GTR No. 9 – Draft proposal for Amendment 2

Note: The text reproduced below was prepared by the chairman and vice-chairman of the informal working group on the global technical regulation No. 9 (Pedestrian safety)-Phase 2 proposing the use of a flexible pedestrian lower legform impactor in the global technical regulation No. 9 (pedestrian safety) - Phase 2. The modifications to the current text of gtr No. 9 on pedestrian safety are marked in bold for new or strikethrough for deleted characters. Text in square brackets is still under discussion and consideration of the informal group.

I. Proposal

Figure 27 Flexible lower legform impactor test set-up for dynamic lower legform impactor certification test, pendulum type (see paragraph 8.1.2.4.)

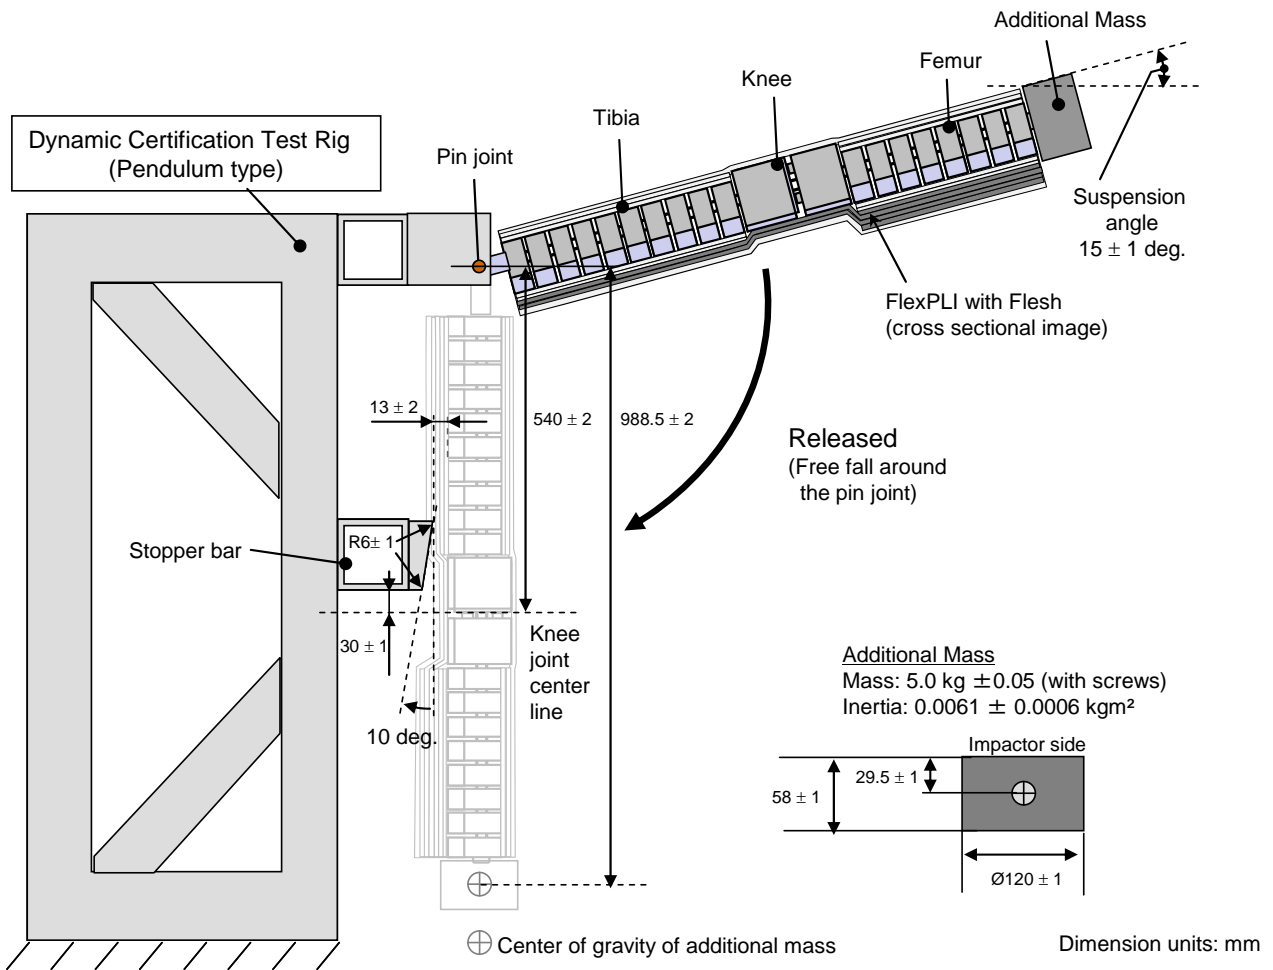
- 8.1.2.4.1. **The flexible lower legform impactor, including flesh, shall be suspended from the dynamic certification test rig $15 \pm 1^\circ$ upward from the horizontal as shown in Figure 27. The impactor shall be released from the suspended position, whereupon the impactor falls freely against the pin joint of the test rig as shown in Figure 27.**

- 8.1.2.4.2. **The knee joint centre of the impactor shall be 30 ± 1 mm below the bottom line of the stopper bar, and the tibia impact face without flesh shall be located 13 ± 2 mm from the front upper edge of the stopper bar when the impactor is hanging freely as shown in Figure 27.**

Figure 28 Flexible lower legform impactor test set-up for dynamic lower legform impactor certification test, inverse type (see paragraph 8.1.3.4.)

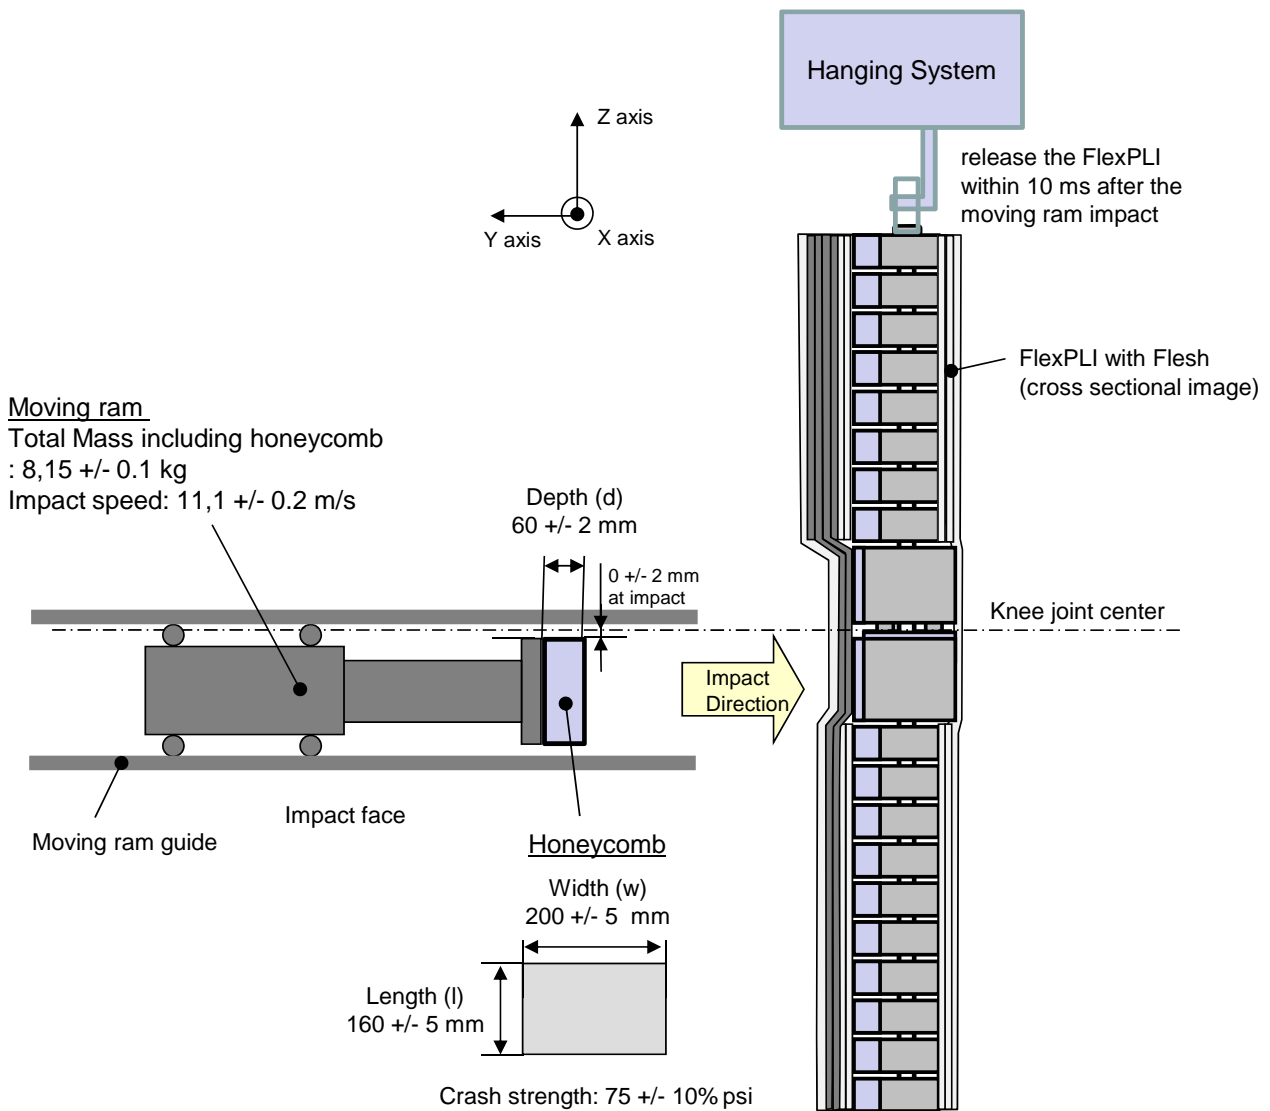
8.1.3.4.1. The fully assembled flexible lower legform impactor (with flesh and skin) shall be stationary suspended vertically from a test rig as shown in Figure 28. It is then impacted by the upper edge of a linearly guided Al honeycomb impactor, covered by a thin (less than 1 mm thickness) paper cloth, at an impact speed of $11,1 \pm 0,2$ m/s. The legform is to be released from the test rig within 10 ms after the time of first contact to ensure a free flight condition.

- 8.1.3.4.4. The flexible lower legform impactor pitch angle and therefore the pitch angle of the velocity vector of the honeycomb impactor (rotation around Y-axis) at the time of first contact shall be within a tolerance of $0 \pm 2^\circ$ in relation to the lateral vertical plane. The flexible lower legform impactor roll angle and therefore the roll angle of the honeycomb impactor (rotation around X-axis) at the time of first contact shall be within a tolerance of $0 \pm 2^\circ$ in relation to the longitudinal vertical plane. The flexible lower legform impactor yaw angle and therefore the yaw angle of the velocity vector of the honeycomb impactor (rotation around Z-axis) at the time of first contact shall be within a tolerance of $0 \pm 2^\circ$, to ensure a correct operation of the knee joint."
